From: Sam Hutchings <SHutchings@greenwoodroche.com>
Sent: Friday, 17 January 2020 3:23 pm
To: Emma Ensor
Subject: Re: Pre-hearing matters NZTE Operations Limited - Obstacle Limitation Surface issue [GREE-DMS.FID113238]
Attachments: Revised Appendix 9 - 17 Jan 2020.docx; Letter to Emma Ensor WDC re OLS compliance 15 Jan 20.docx; Te Kowhai OLS Shapefile.msg; FW_ Te Kowhai OLS Shapefile.msg; Proposed OLS Sent Nov19.zip; OLS Shapefile.jpg

Appendix 9: Te Kowhai Airfield

Te Kowhai Aerodrome Obstacle Limitation Surfaces

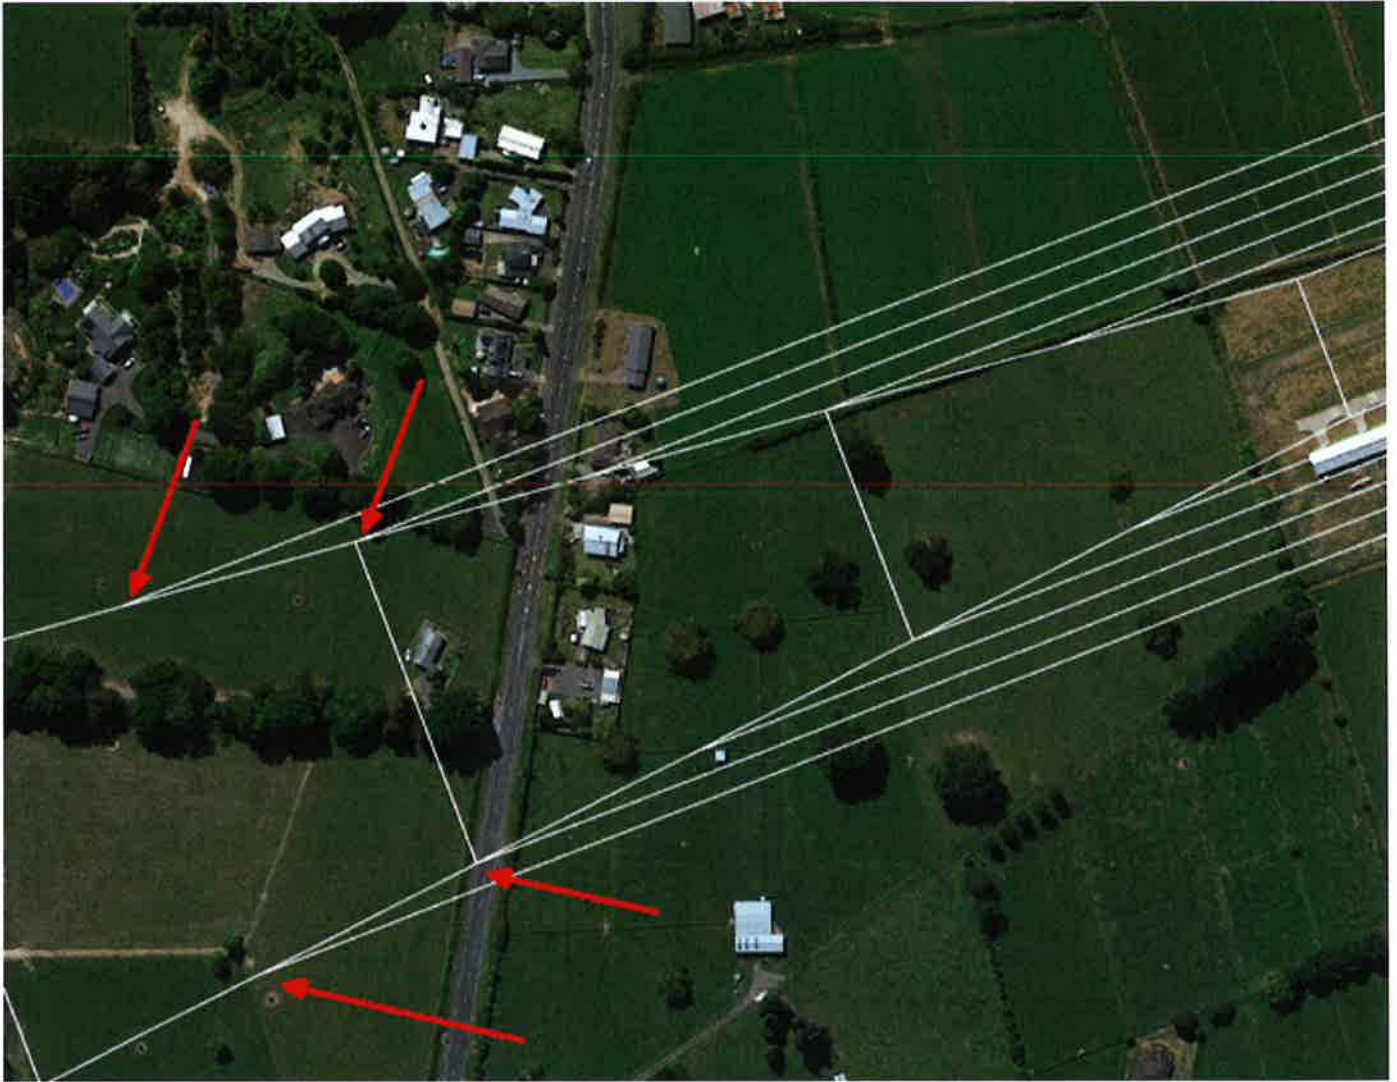
Upon review of the Proposed District Plan obstacle limitation surface map layer against the text in section 3 of Appendix 9, it appears that the Proposed District Plan obstacle limitation surface map layer may be mapped incorrectly with respect to the location of the approach surface starting point locations.

The approach surface starting point locations are supposed to be located "at the end of the runway strip". However, the Proposed District Plan map at present may in fact be showing the approach surface starting points at the ends of the runway, rather than the ends of the runway strip.

Can you please review the Proposed District Plan airport obstacle limitation surface as currently mapped and review the appropriate text within Appendix 9 of the Proposed District Plan?

1. Whether or not the text in Appendix 9 in the Proposed District Plan relating to the Obstacle Limitation Surface is worded as originally intended during district plan development.
2. Whether or not the Obstacle Limitation Surface as currently mapped on the Proposed District Plan is mapped correctly to reflect the Appendix 9 wording.
3. Whether or not the approach and take-off surface starting points have been correctly mapped on the Proposed District Plan map.

Upon reviewing the proposed district plan map, I can confirm that:

- The wording needs to be amended to describe the OLS using terminology that more appropriately reflects the relevant CAA standards and to more accurately describe the location and shape of the OLS.

- Please see the attached file 'Revised Appendix 9 – 17 Jan 2020.docx' with the changes.
 - The Approach and Take-Off Surfaces begin approximately 40m inwards from the ends of the runway strip (exact values within the document). This is to clear the fences at the end. This does not change the location of the runway strip – the coordinates shown in the chart of Appendix 9, Section 2 are correct. This space can still be used start of take-off and the end of landing, as confirmed by Aviation Consultant Dave Park in the attachment 'Letter to Emma Ensor...'

- The map is incorrect, however not as mentioned in point 3.
 - The starting points for the OLS are shown correctly, as are the take-off and approach fans on both ends. The transitional side surface and the oval representing the inner horizontal surface are incorrect.

February 2018 Version, with horizontal surface at 2000m instead of 2500m and the sides not tapered to meet the equivalent height in the take-off/approach fan:

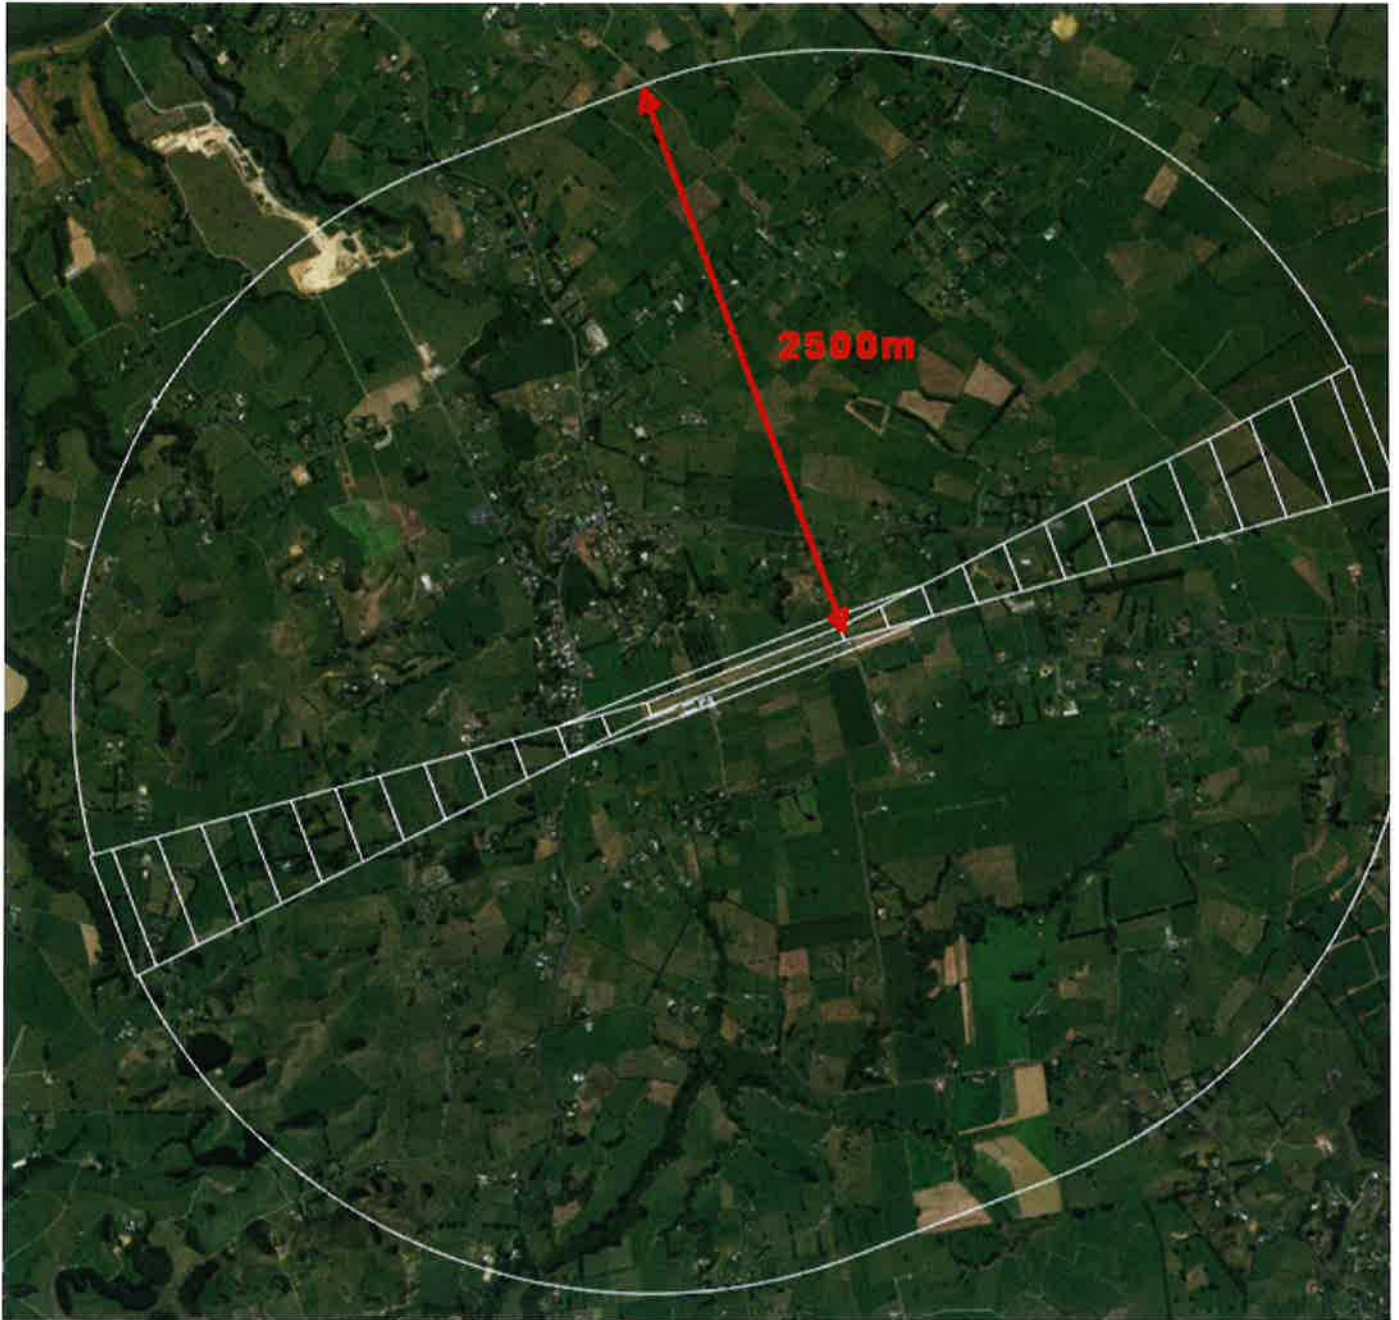
- This one shown on the proposed planning maps is not consistent with the shape file that was sent to Council in March 2018.
 - An early version was generated in February 2018 which is what is shown. This incorrectly shows the transitional surface without tapering in, and also shows the inner horizontal surface extending to 2000m instead of 2500m. (shown below)

- An updated version noting both of those changes was sent to Kevin Stokes at council in March 2018, and specifically notes in the email the tweaked transitional sides and the horizontal surface extending to 2500m. At the time, these shape files were generated in Mount Eden 2000 coordinates. Two emails titled 'Te Kowhai OLS Shapefile.msg' are attached – the first with the file (without the horizontal surface however) and one twenty minutes later with the horizontal surface following verbal instructions to include it. (shown below)

- Another shapefile was sent on Council's request on 22 November 2019. This one was generated in the requested NZTM coordinates, and also includes the strip ends (the ones to Kevin did not show the extent of the runway strip, only up to the OLS Commencement points). The GIS files are include in an attached zip file, and also the portion included shown below.
